ATCO Gas and Pipelines Ltd.

2014 PBR Capital Tracker True-Up and 2016-2017 PBR Capital Tracker Forecast

Decision 20604-D01-2016 ATCO Gas and Pipelines Ltd. 2014 PBR Capital Tracker True-Up and 2016-2017 PBR Capital Tracker Forecast Proceeding 20604

Figure 1 Figure showing the service density vs cost (2013 project list) for the PMR program²³⁶

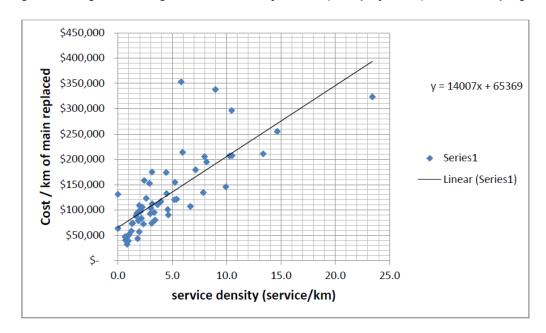
- 205. ATCO Gas stated that once it established the annual level of expenditures required to complete the program over the remaining 15 years, it used regression analysis to determine the forecast number of km and services to be replaced in 2016 and 2017. ATCO Gas submitted that service density is the most influential factor driving costs associated with the replacement of PMR mains. In the business case for the PMR program, ATCO Gas provided a figure, for illustrative purposes, where a line of best fit was determined to show the relationship between service density and cost. ATCO Gas used only data on 2013 projects to determine the line of best fit. In the hearing, Mr. Germaine confirmed that this figure was not used to build the 2016 and 2017 forecast and that the line of best fit included in this illustration was obtained using

regression analysis applied jointly to the north and south data.²³⁴ ²³⁵ The figure is reproduced below:

- 227. For example, in a regression where cost per km depends on service density, parties would benefit from being provided with the explicit values of service density for each region and year that are inputted into the estimated regression equations to yield cost per km forecasts for the those regions and years. In a response to a Commission aid to questioning, service densities were calculated and provided by the Commission, and ATCO Gas's witness confirmed that the service densities "look approximately correct." Based on the Commission's calculations provided in Table 12, the Commission finds that the implied service density values for each region for 2016 and 2017 are approximately consistent with the overall service densities for these years presented in Table 8, as can be confirmed by multiplying the implied service density for each region by the number of km for each region found in Table 11, and then summing across the two regions.

- 228. The Commission considers that it would be helpful to all parties if ATCO Gas were to provide a more complete presentation of the regression models and accompanying analysis, separately for each region in which the analysis is conducted. A more complete presentation might include a variety of regression diagnostic statistics such as the number of observations used, the time period used, the goodness of fit statistic, estimated standard errors of all the estimated parameters, the estimated standard error of the regression, tests of parameter significance, and tests of whether the regressions for different regions are statistically significantly different. In addition, if cost data used to estimate a particular regression include

- 229. As a further consideration, ATCO Gas could determine the estimated standard errors for forecasts of cost per km for different regions in different years, so that the uncertainty associated with these forecasts can be evaluated. Interested parties, as well as ATCO Gas, may also benefit from an evaluation of alternative regression models that employ standard regression diagnostic procedures, such as individual and joint tests of significance of parameters. These alternatives could include models with multiple explanatory variables where, for example, service density is replaced by separate variables for the number of services and pipeline length.
